STAFF RECOMMENDATION
717 Fatherland Street
January 20, 2021

Application: New Construction – Infill and Outbuilding
District: Edgefield Historic Preservation Zoning Overlay
Council District: 06
Base Zoning: R8
Map and Parcel Number: 082160443.00
Applicant: Van Pond
Project Lead: Jenny Warren, jenny.warren@nashville.gov

Description of Project: Application for the construction of infill and an outbuilding.

Figure 2: Front elevation of proposed infill.

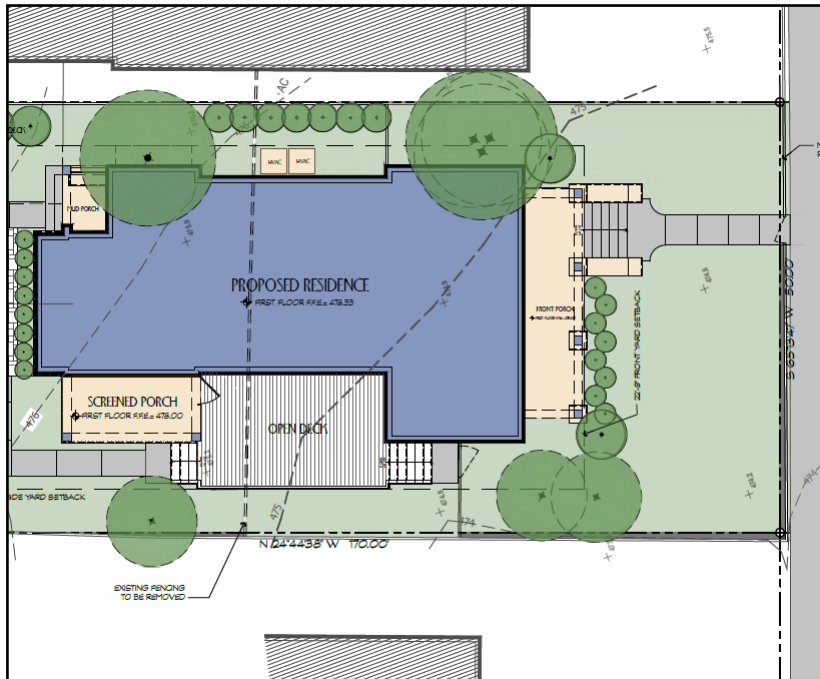
Height & Scale: The proposed house will be a full two-story form and will be approximately twenty-eight feet (28') tall with about a twenty-one and a half foot (21'6") eave, from grade. The nearby historic houses are one-and-a-half or two stories tall and range in height from about sixteen to thirty-nine feet (16'-39') in height. The foundation at the front is about two to three feet (2'-3') tall. The historic houses next door at 719 Fatherland Street, and the two houses across the street at 714 and 718 Fatherland all have comparable foundation heights. Staff finds the proposed height to be appropriate for the context.

The width is proposed to be about thirty-two feet (32'). There is a second floor projecting bay which adds approximately two feet, six inches (2'6") of additional width. Nearby historic house range from about thirty to about thirty-nine feet (~30'~39') in width. Staff finds that the width of the proposed infill is appropriate.

The project meets sections III.B.2.a and b.

Figure 7: Right side elevation. Note squared accent windows.

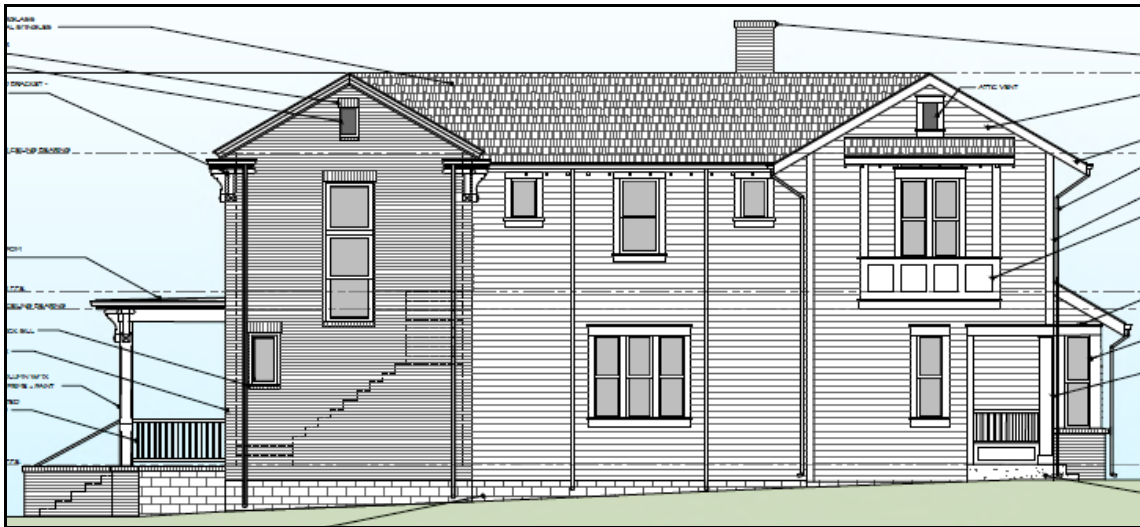
Proportion and Rhythm of Openings: The windows are all generally twice as tall as they are wide, thereby meeting the historic proportions of openings. There are a few squared windows, one on the front elevation and a few on the right-side elevation (Figure 7) – staff finds that these could be appropriate as they are accent windows and not the primary window type. There are no large expanses of wall space without a window or door opening. Staff finds the project’s proportion and rhythm of openings to meet Section III.B.2.f.

Figures 8 & 9: North and west elevations of garage. Note slope.

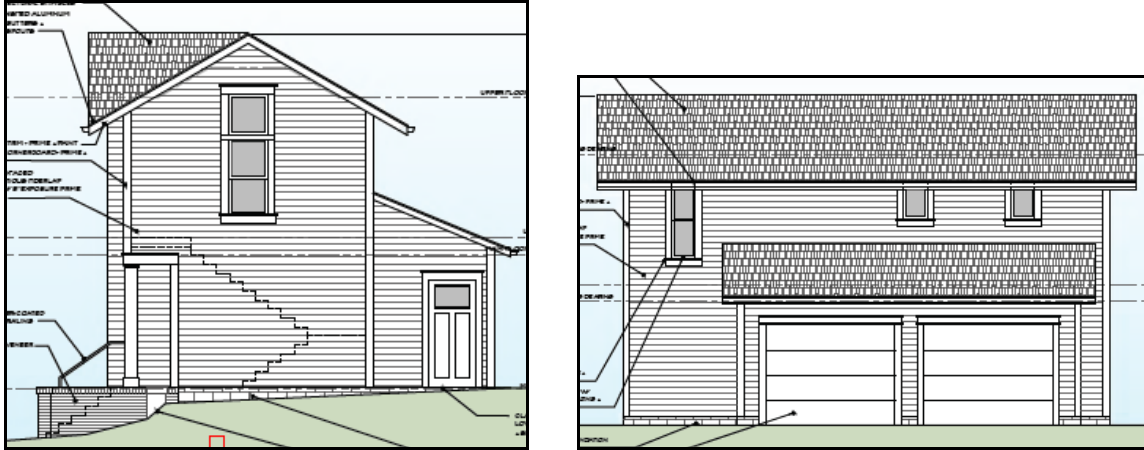
The site of the proposed DADU has significant changes in grade. (Figures 8 & 9) On average, the ridge and eave heights will meet the guidelines. Although they will be a bit taller on the downslope, they will be a bit shorter at the higher elevation. Staff finds that this is appropriate.

The proposal meets Section III.B.2.h.1 of the design guidelines.

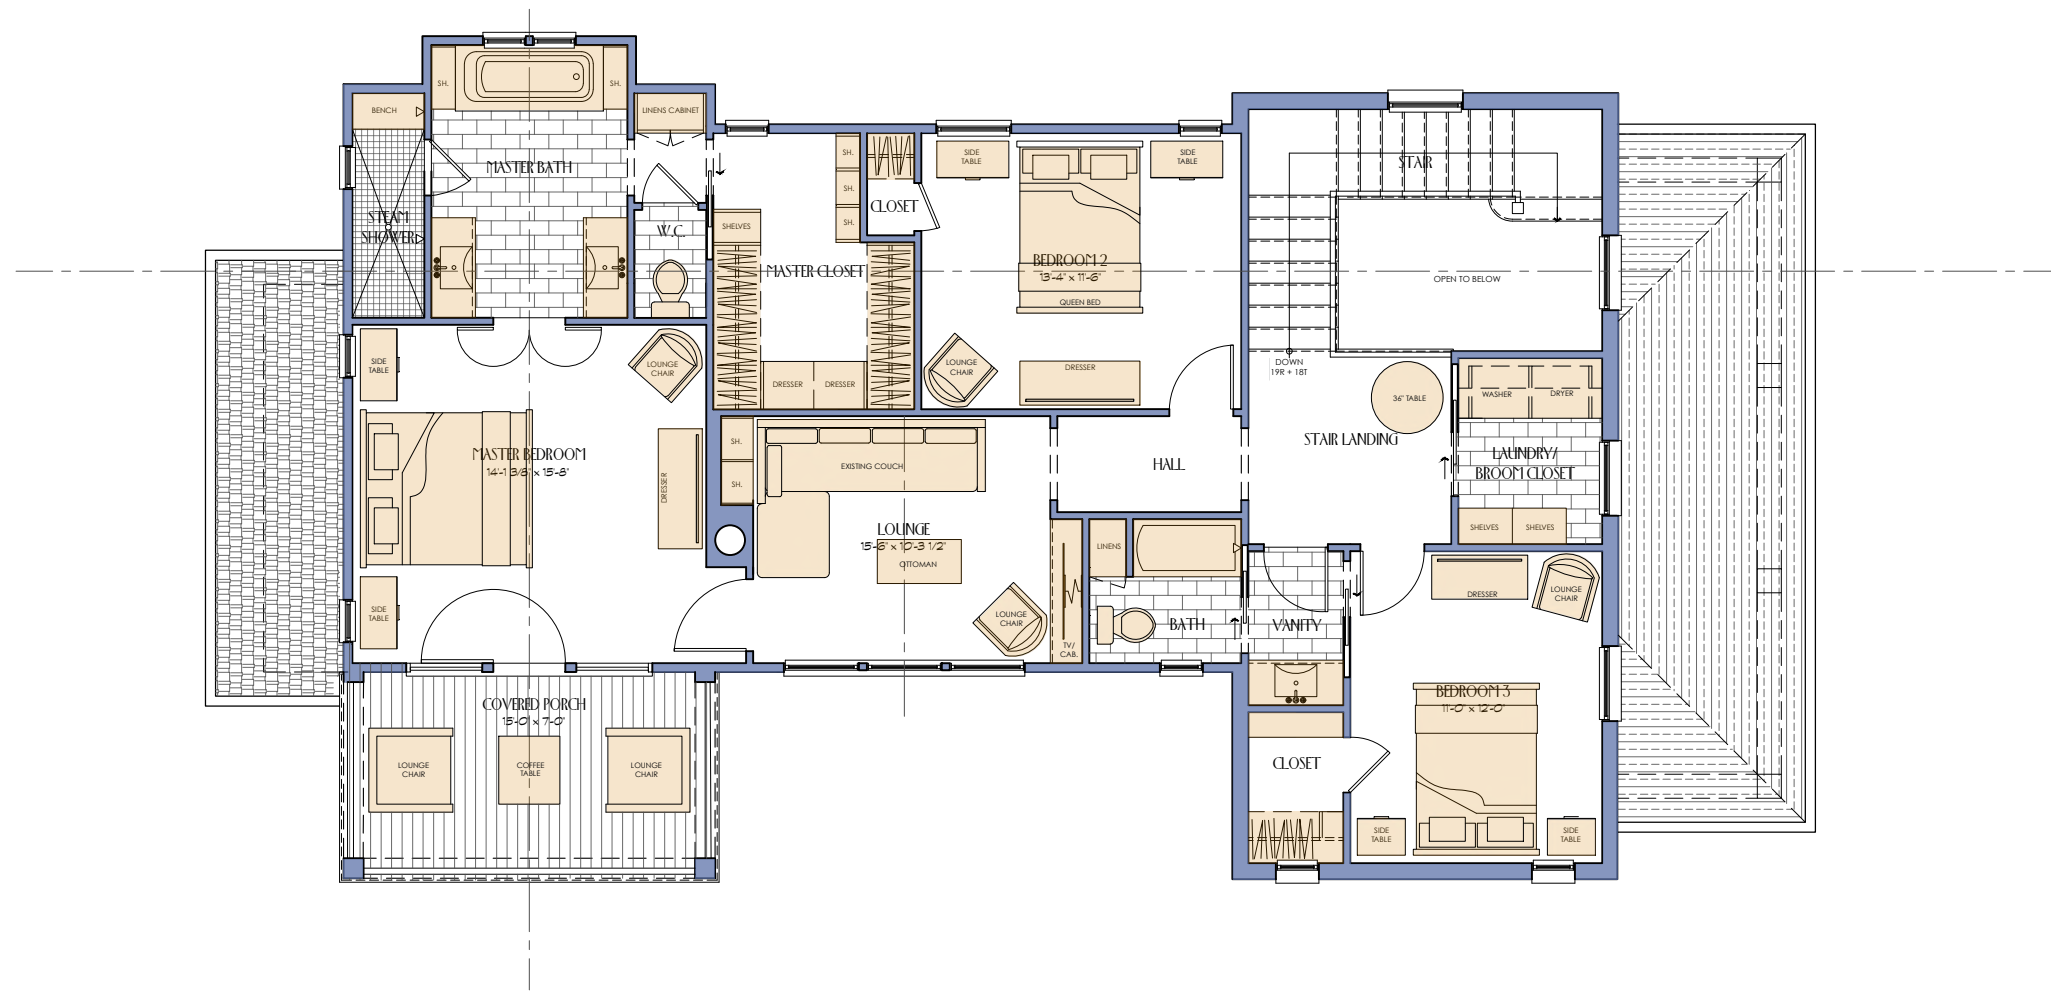
On the right side, the main wall of the house will be about seven feet (7') from the side property line – the second floor projecting bay will extend about two feet (2') closer to be

right at the setback line, five feet (5') from the property line. The left side will be about ten feet (10') from the side property line. The rear will be more than eighty feet (80') from the rear property line.

The project meets section III.B.2.a.
